Title: **MEETING WITH ADVISORY COMMITTEE ON
REACTOR SAFEGUARDS (ACRS) - PUBLIC
MEETING**

Date: **Thursday, June 8, 1995**

SUBJECT: NRC TEST AND ANALYSIS PROGRAM IN SUPPORT OF AP600 ADVANCED LIGHT WATER PASSIVE PLANT DESIGN REVIEW

SUBJECT: NRC TEST AND ANALYSIS PROGRAMS IN SUPPORT OF AP600 AND
SBWR ADVANCED LIGHT WATER REACTOR PASSIVE PLANT DESIGN
CERTIFICATION REVIEWS

FIGURE 3.2 SAFETY GOAL SCREENING CRITERIA

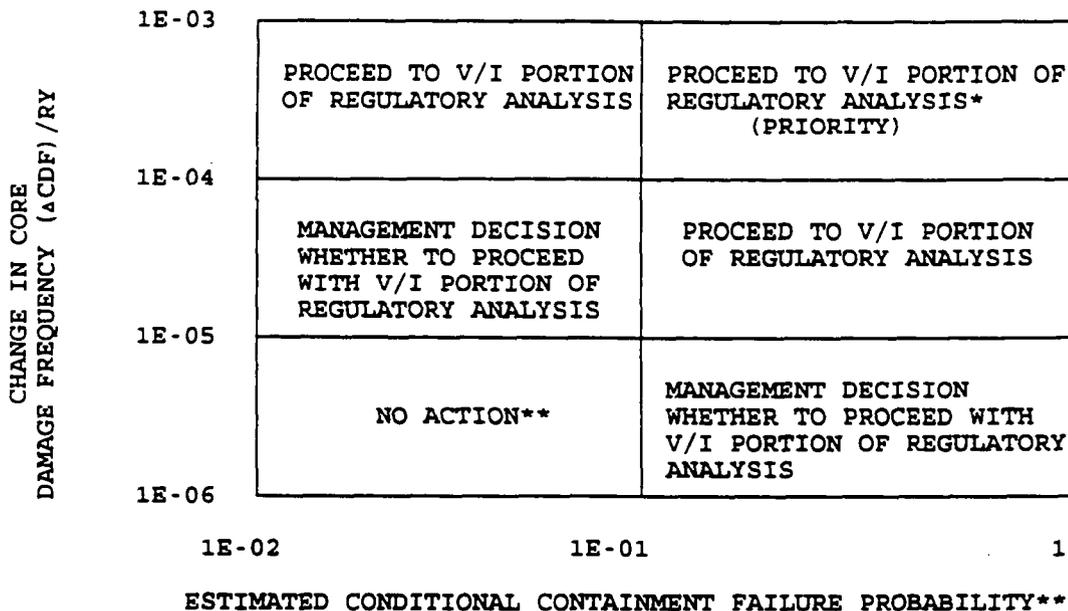
Figure 3.1 of the proposed guidelines should include a step in which a determination is made on whether the proposed enhancement is something that can be evaluated by quantitative risk estimates. If so, we believe that PRAs must be used to quantify the benefits. If not, the analysis would go to a different decisionmaking scheme (e.g., expert opinion, engineering/regulatory judgment).
